**From:** Proffitt, Sydney <Sydney.Proffitt@kimley-horn.com>  
**Sent:** Thursday, September 19, 2024 1:16 PM  
**To:** Cherne, Curtis; Trujillo, Concetta M.  
**Cc:** Willmot, Liz; Regina Okoye  
**Subject:** RE: RC1156 Albuquerque, NM Raising Cane's TCL- streetlight in sidewalk?  
**Attachments:** RC1156\_Albuquerque\_NM\_TCL Resubmittal\_2024.09.19.pdf

We are working on a Raising Cane's on the SW corner of St. Joseph's Drive and Coors Blvd NW. We are addressing our second round of building permit comments and had a question.

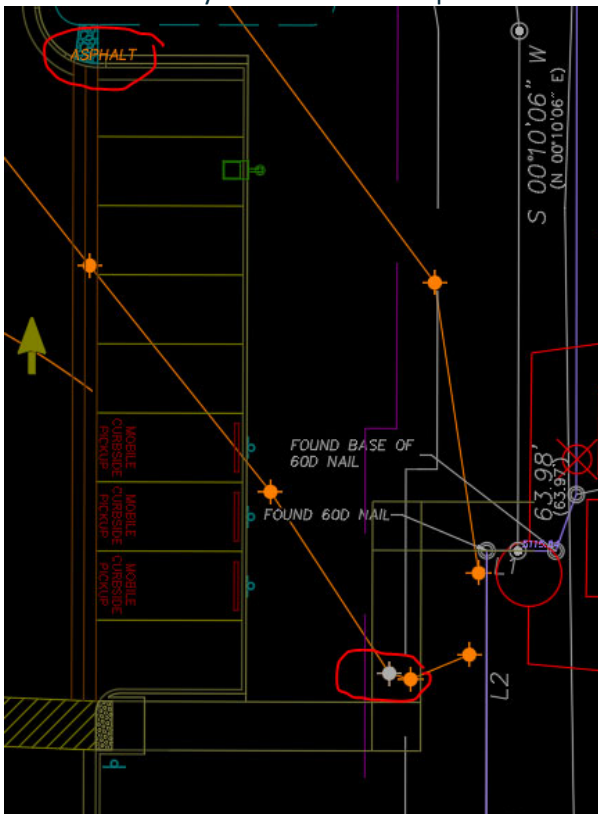
Sydney,  
Is there an existing street light in the proposed new location of the sidewalk?  
I see the symbol on the plan.

I've fixed that in our plans, please see attached. Let me know if you need anything else from us!

I've attached our ALTA for your reference. It looks like it is just a point on the edge of the existing asphalt onsite that will be demolished by the overall developer that was accidentally left off a demo layer.

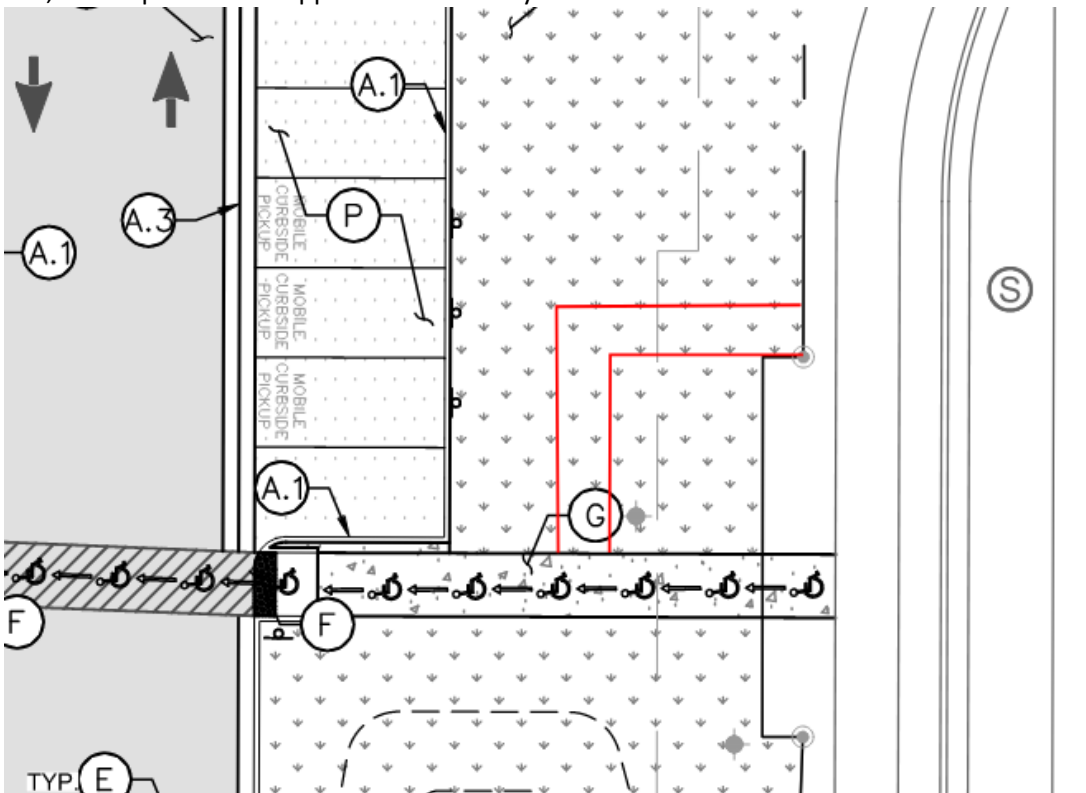
We received TCL Approval on 4/23/24 and have included our stamped TCL plans and approval letter in our building permit submittals. I have attached these files for reference. In the second round of comments, we received a note to correct our parking calculations. We are working to update those based on the comments provided. We also have been coordinating with the overall developer and will need to make a slight adjustment to the sidewalk on the east side of our site, see snip below for approximate new layout.

What the timeline is for getting these TCL plans reapproved with the two minor changes above? Can we submit directly through you all or do we need to go through PLNDRS? We can provide these revised drawings tomorrow.

Sydney,  
 The sidewalk change is minor.  
 What needs to be changed for the parking calcs?
